Access Compliance Report

Public Rights-of-Way

(Pedestrian Signals)

Intersection ID: N/A	Main Street:	Cross Street: N/A	Location: N/A
ADA ID: B6896836515B	Signal Type: One Push Button-Non APS	Overall Compliance: No	Severity Score: BTN 1: N/A BTN 2: N/A No BTN: N/A
Codes/Mitigation Info/Possible Solution		Field Measurements/Component Compliance

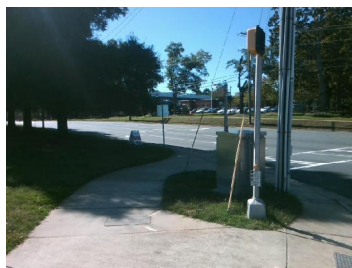
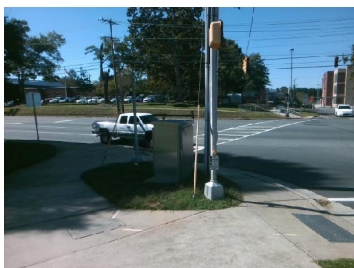
PROW/ADA: TMUTCD 4e.08, R404.2, R404.3, R404.7.3

Yes	B 1 Clear Xing Direction?	ClearlyMarked	N/A	B 2 Clear Xing Direction?	N/A
	B 1 Crossing Direction	To NW		B 2 Crossing Direction	N/A
Yes	B 1 DistanceTo XWalk (in)	0.0	N/A	B 2 DistanceTo XWalk (in)	N/A
No	B 1 DistanceTo Curb (in)	76.0	N/A	B 2 DistanceTo Curb (in)	N/A
Yes	B 1 Diameter (in)	2.0	N/A	B 2 Diameter (in)	N/A

Possible Solutions: Replace Signal Push Button With APS Button on New Post. Remove & Relocate Sign.
